# Zonnequa Wind Farm, Northern Cape Province

Motivation for amendment of Environmental  
Authorisation

DEA Ref.: 14/12/16/3/3/1/1970

October 2019

**Figure 9.1:** Amended Zonnequa Wind Farm layout overlain with environmental sensitivities, including updated bat sensitivity buffers (A3 Map included in Appendix I)

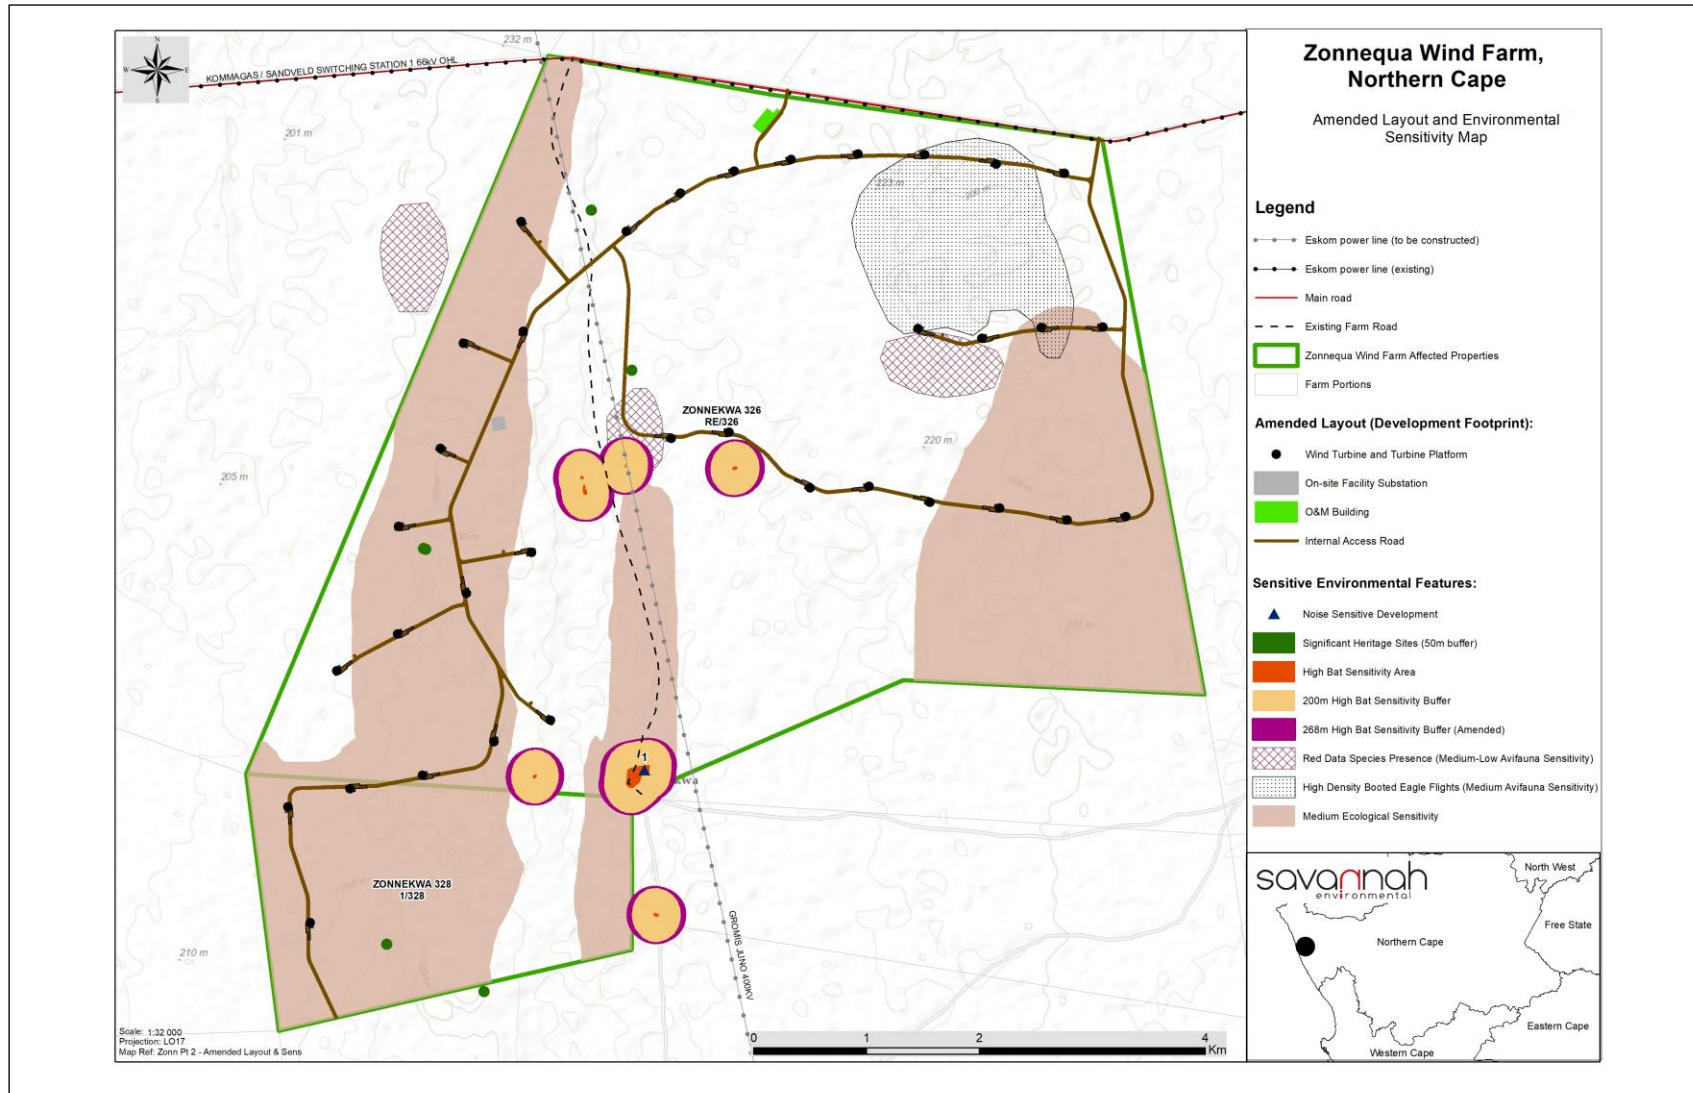
The requested amendments of the turbine specifications and number, as well as the layout will result in an optimisation of the layout assessed within the BA and the avoidance of sensitive areas. It must be noted that this amended layout is submitted to DEFF for review and approval in accordance with Condition 13 of the EA.
